MUNICIPAL CORPORATION,
KARACHI

ORDER UNDER SCH. VI, CHP. XI, RULE 5 (1) OF
ACT XVII OF 1933.

With reference to your application with plan for W.C.
on plot 14 Sheet No. 6-7 Quarter received in this
office on 22/7/38 I have to inform you that the said plan is
approved and permission to build in accordance therewith is hereby granted. The
building must be erected in conformity with the Bye-laws and rules of the Karachi
Municipal Corporation.

PLAN OF PROPOSED W.C & WASH PLACE ON PLOT FOR HINDU COMMUNITY
MACHHI MIANI QUARTER) TEMPLE AT THE JUNCTION OF EDULJI
DINSAW & HARRIS ROAD (K.P.T.)
SCALE 1/4" TO A FOOT.

PLAN of PROPOSED W.C. ON PLOT NO. 14/57
MACHHI MIANI QUARTER -
SCALE 1/4" TO A FOOT.

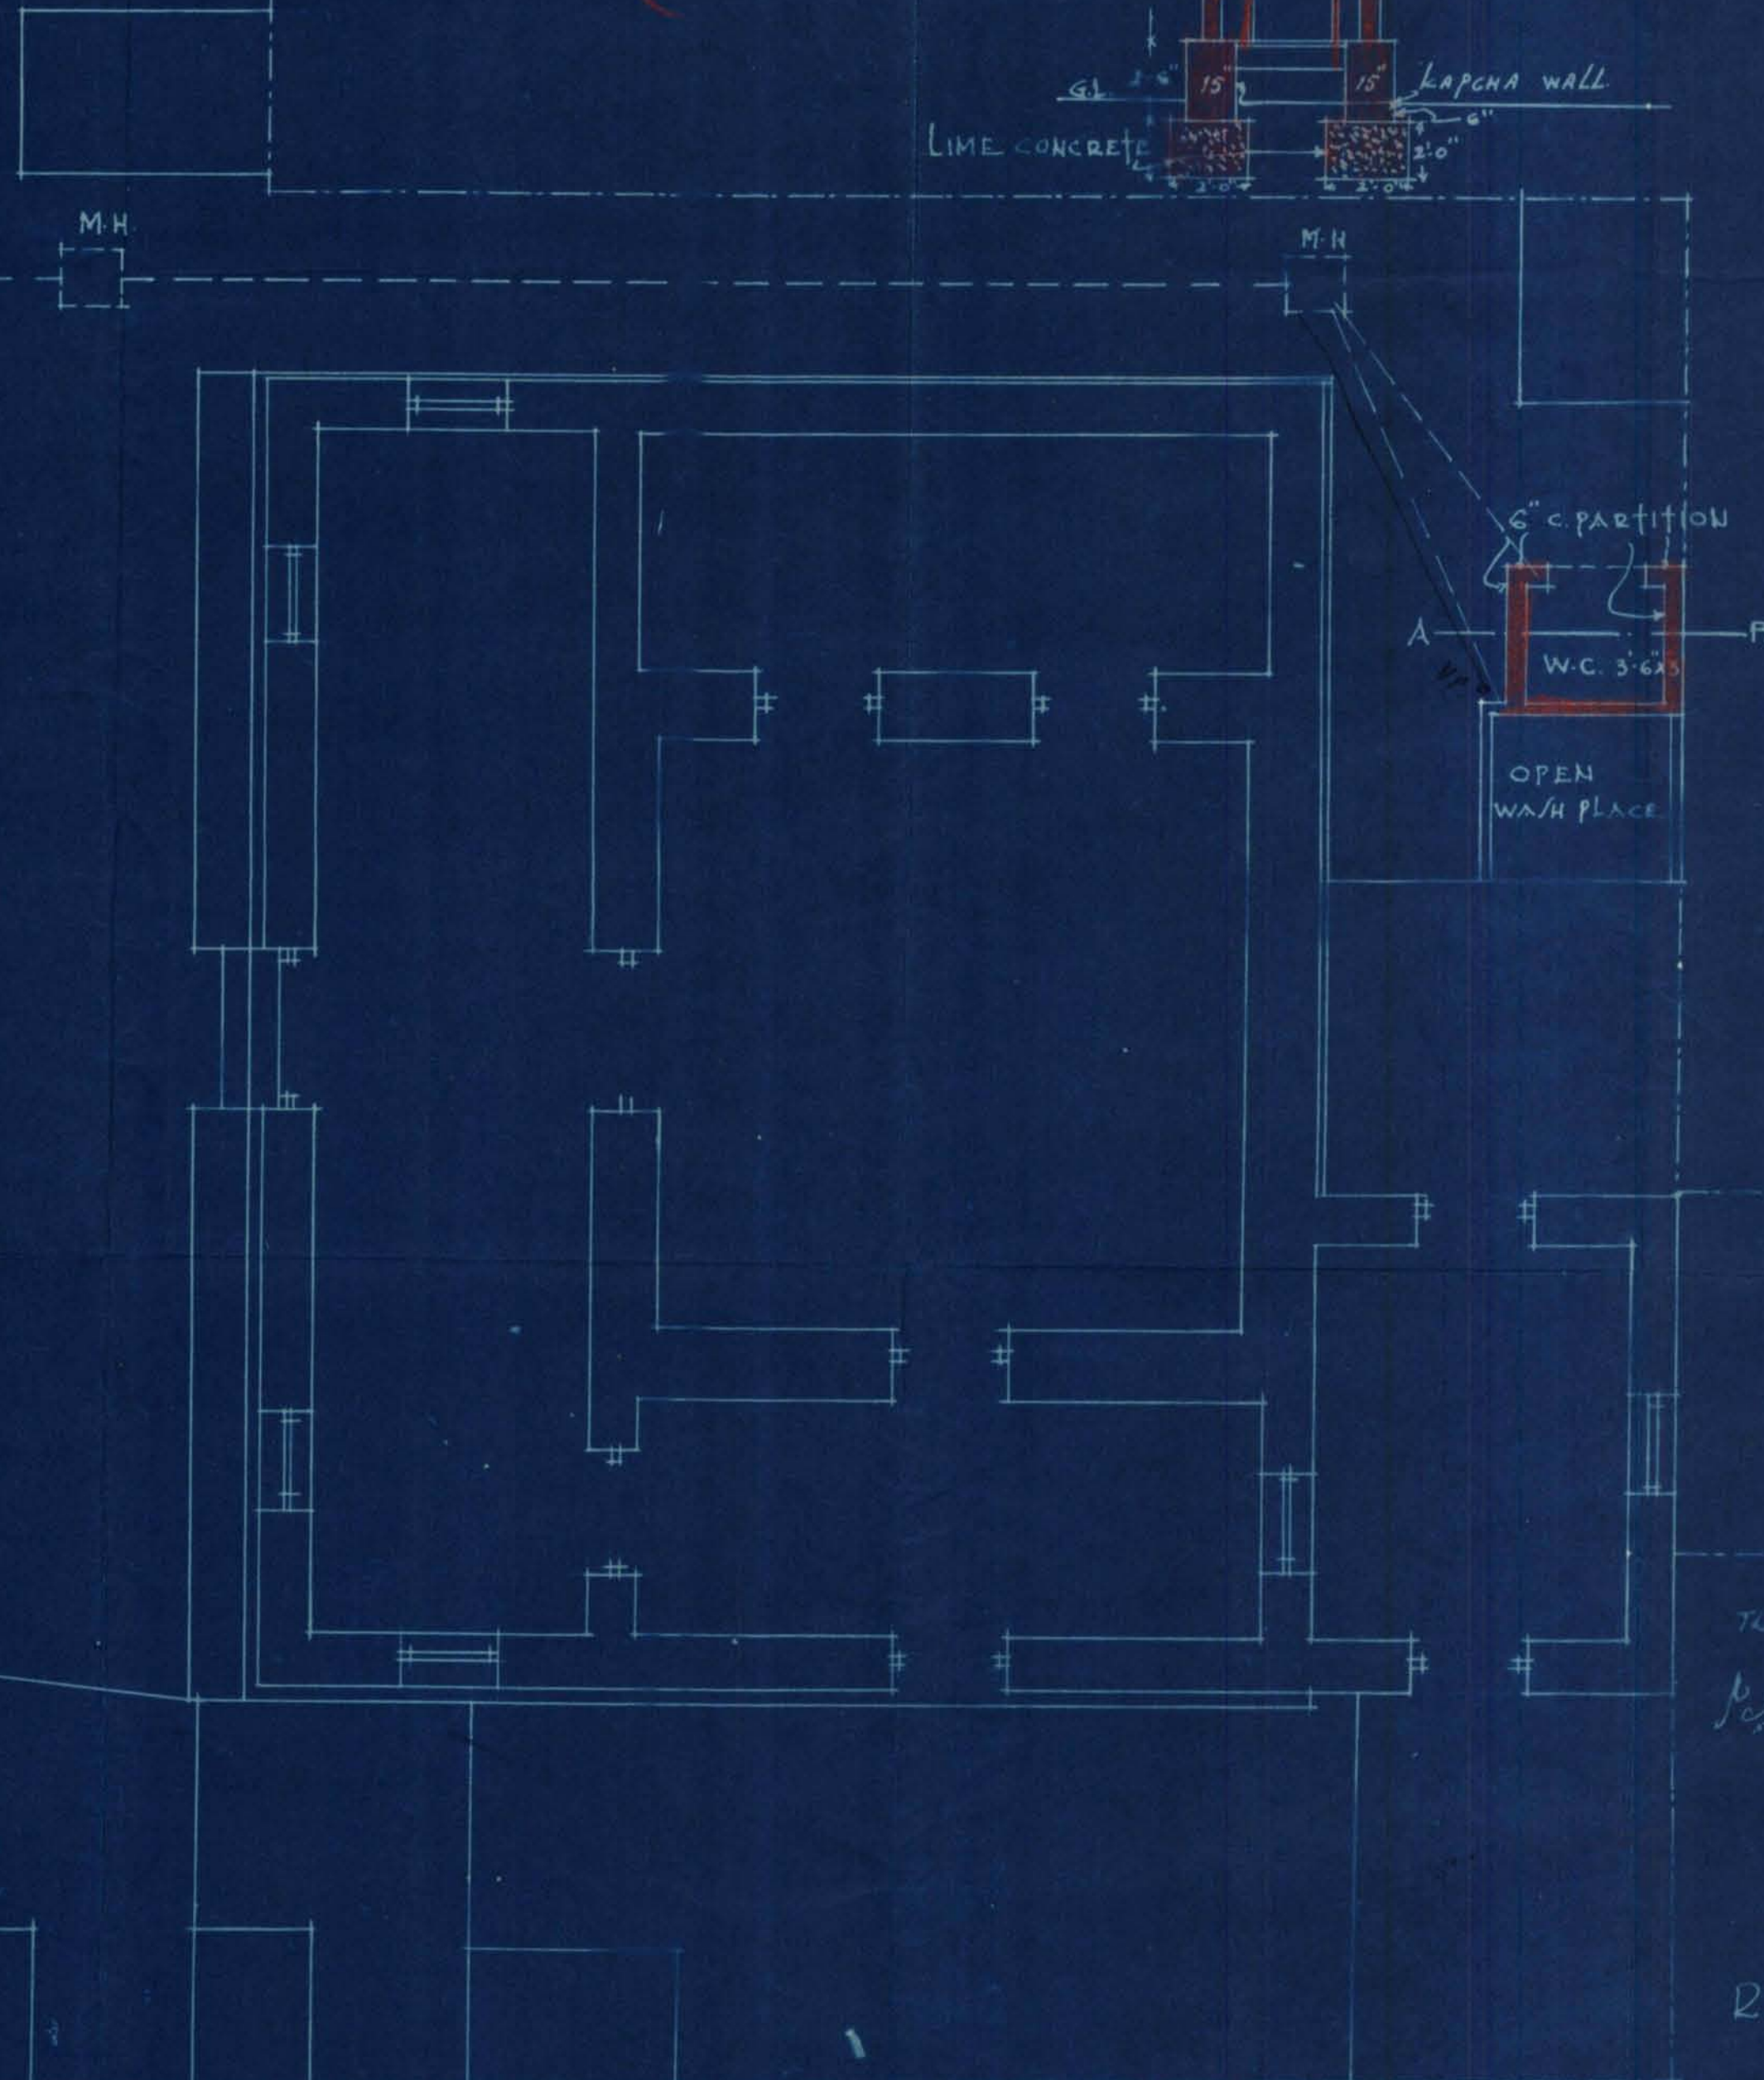
site plan is not attached.

1. New plot No to be given
2. The site plan be attached, and shown in the plan

Site plan to be shown in the plan &
number according to new survey be given

6/12
 Pl attach site plan before
 plans can be considered.

*has Plot no. to be given
for Plot no.
6/12*

With reference to your letter No 564/37
dated 13-12-37, I am sending you the plan
after complying with your requirements.

(1) This plot was granted for temple to
Hindu Community in exchange of P.T. 14/27
by K.P.T. and there is no separate map for
it.

(2) The site plan is shown as given by
the K.P.T. on 4' scale where the proposed
for use is also shown.

PLAN OF PROPOSED W.C. AND WASH PLACE ON PLOT NO 14/C7
MACHHI MIANI QUARTER
SCALE 1/4" TO A FOOT

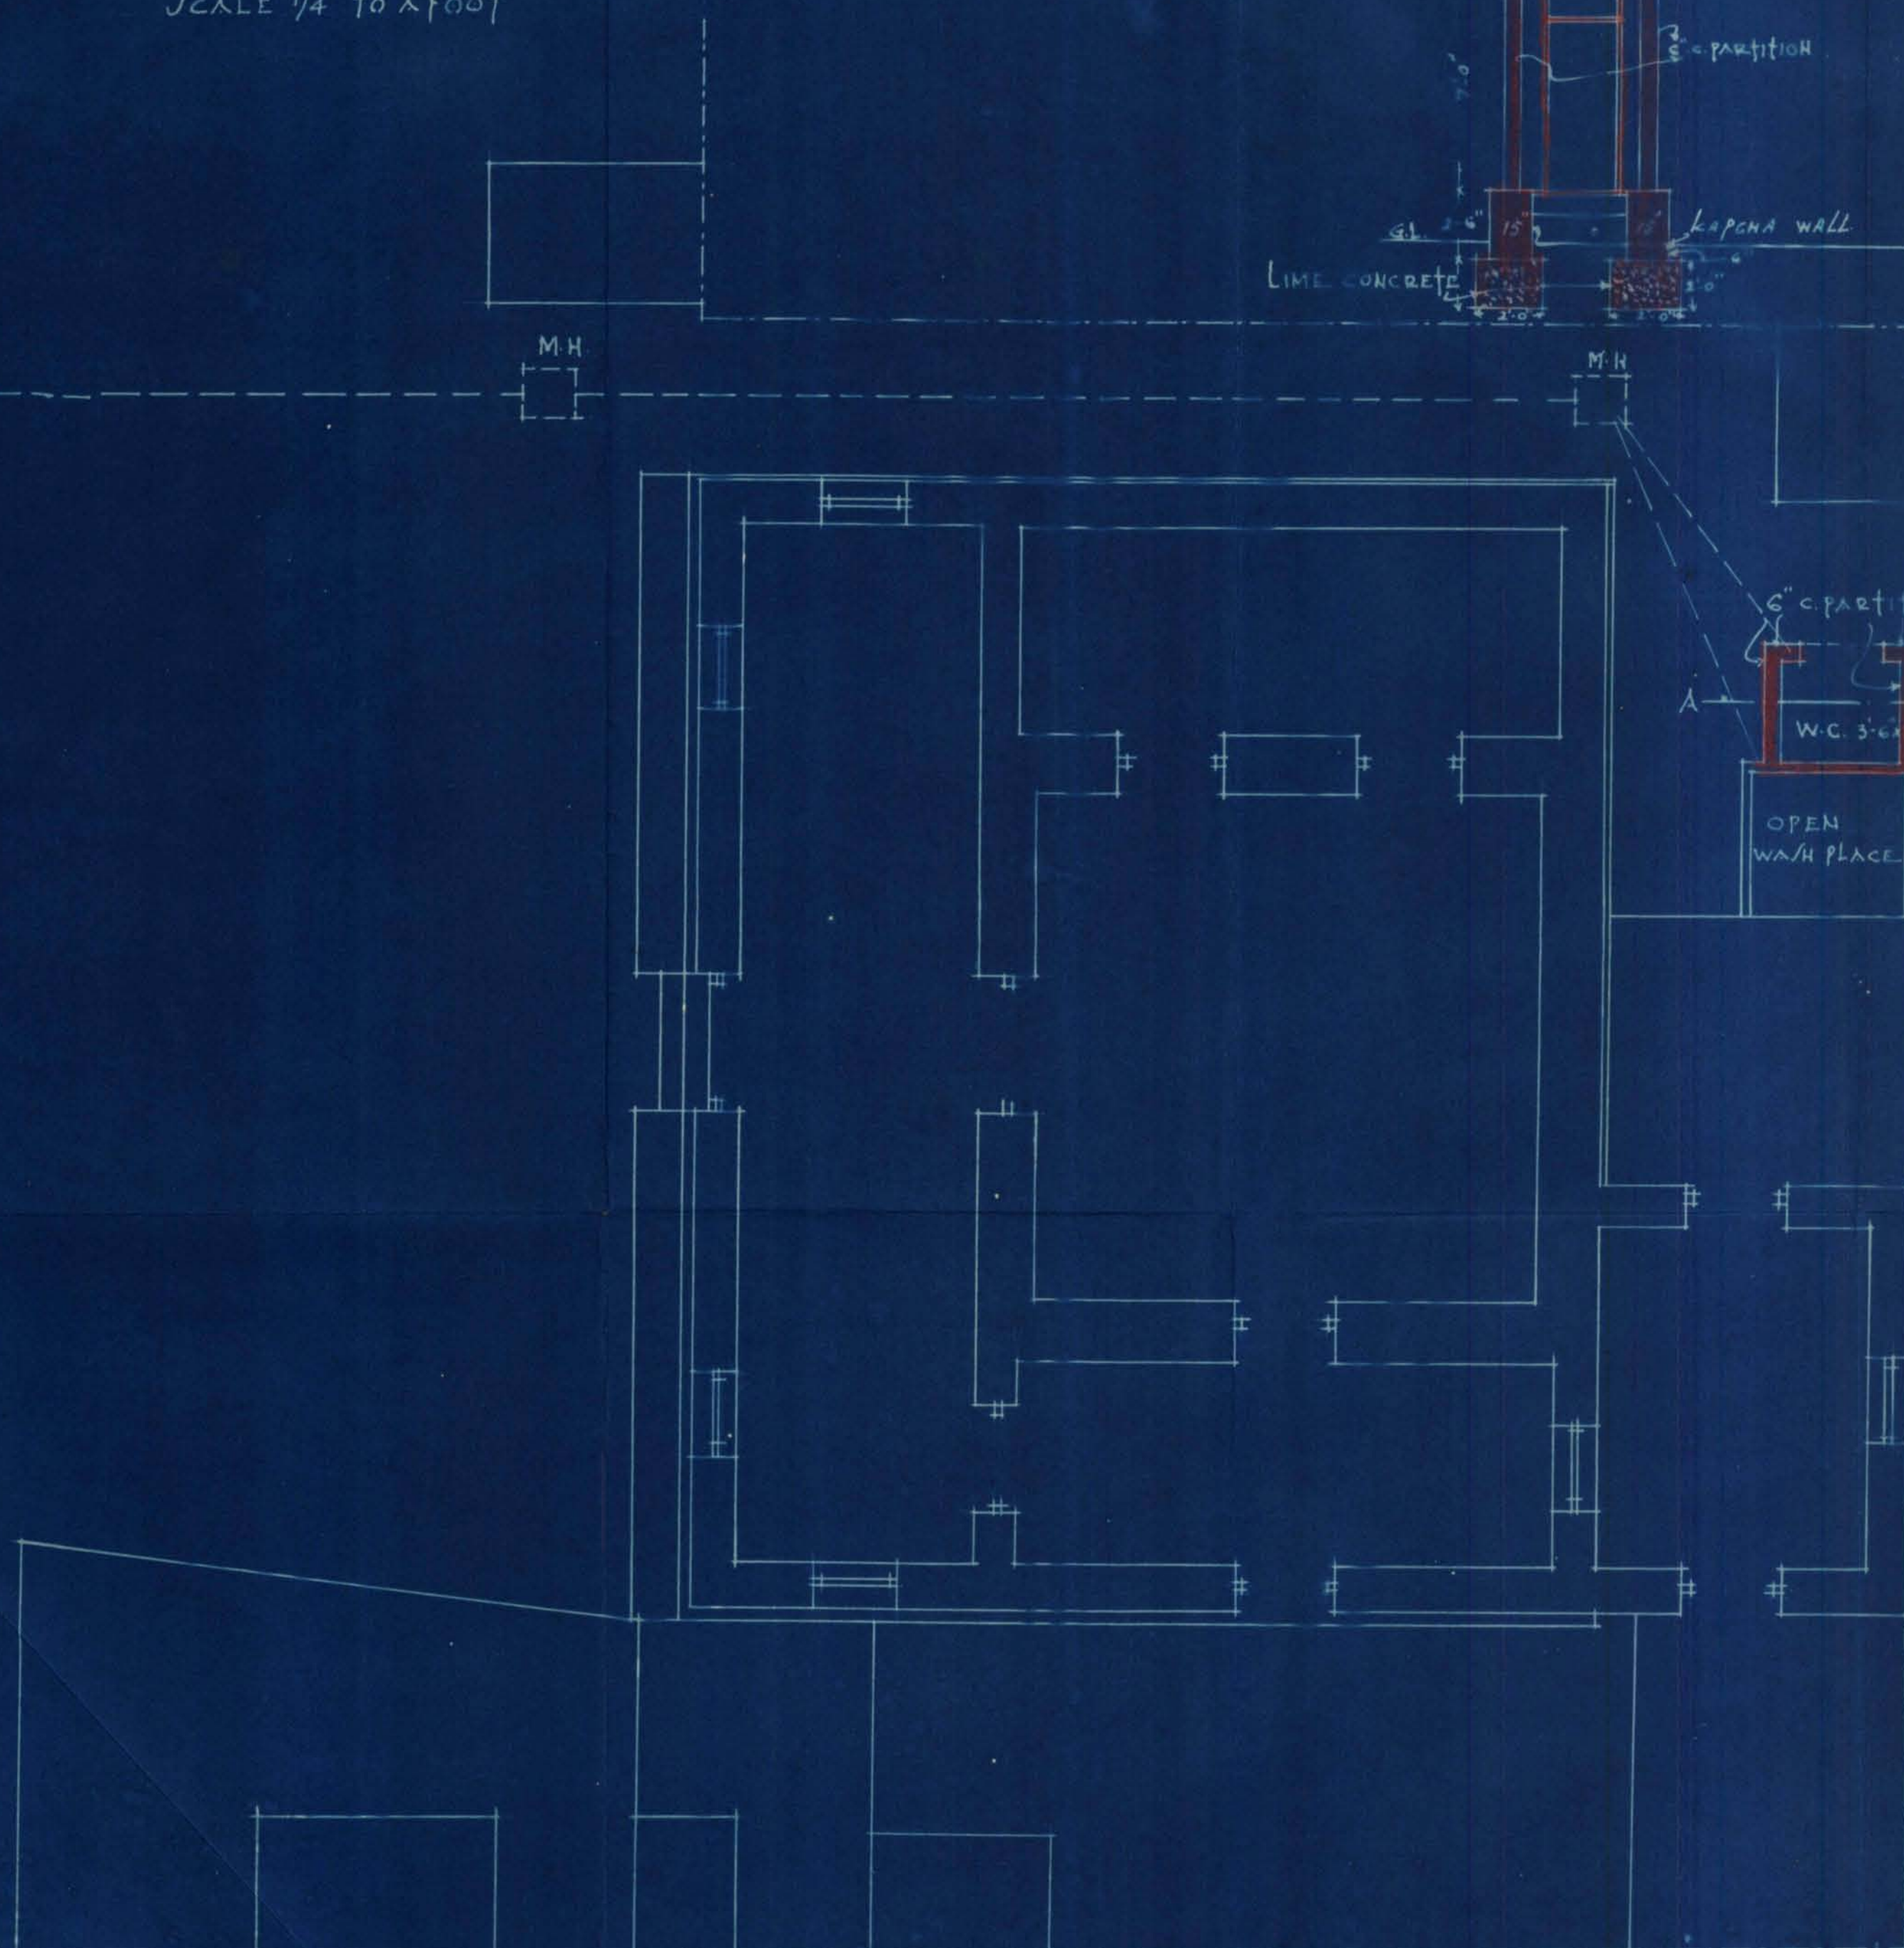
1. Vent pipe should be provided to I.T.M. Hole.
2. Intercepting trap manhole should be located in the owner's limits.

3. There is an obstruction in the shape of the cement plot form of a pipal tree coming in the way of drainage connection being made. The drainage will have to pass under this platform.

1. Vent Pipe should
be provided to I.T.M. Hale.
2. Intercepting
trap manhole should
be located in the
owner's limits.
3. There is an
obstruction in the
shape of the ^{concrete platform of a} ~~tree~~
Pipal tree.
1. ^{Coming} in the way
of drainage connection
being made. The drain
will have to pass under this
platform.
